ADDENDUM NO. 1

FORT LEONARD WOOD READINESS CENTER
REPAIR RANGE 18A EROSION
ST. ROBERT, MISSOURI
PROJECT NO. T2230-01

SHEET C-105: TYPICAL RIP RAP CHANNEL DETAIL

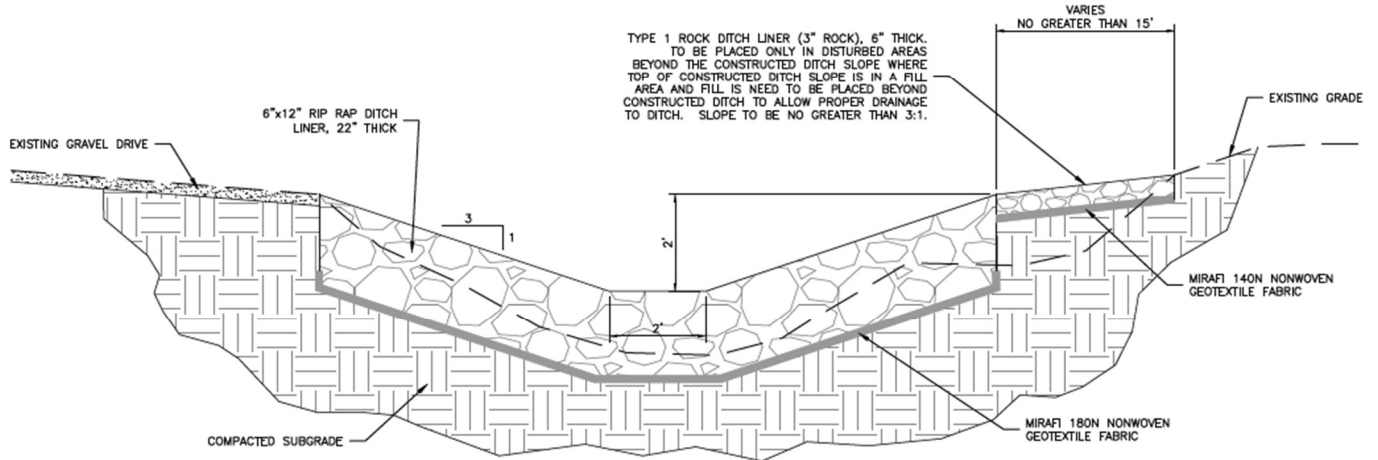
Drawing C-105

TYPICAL RIP RAP CHANNEL DETAIL

DELETE: DETAIL AS SHOWN ON PLAN SHEET

ADD: ATTACHED TYPICAL RIP RAP CHANNEL DETAIL

ADD: ATTACHED TYPICAL RIP RAP CHANNEL DETAIL ALONG GRAVEL DRIVE.
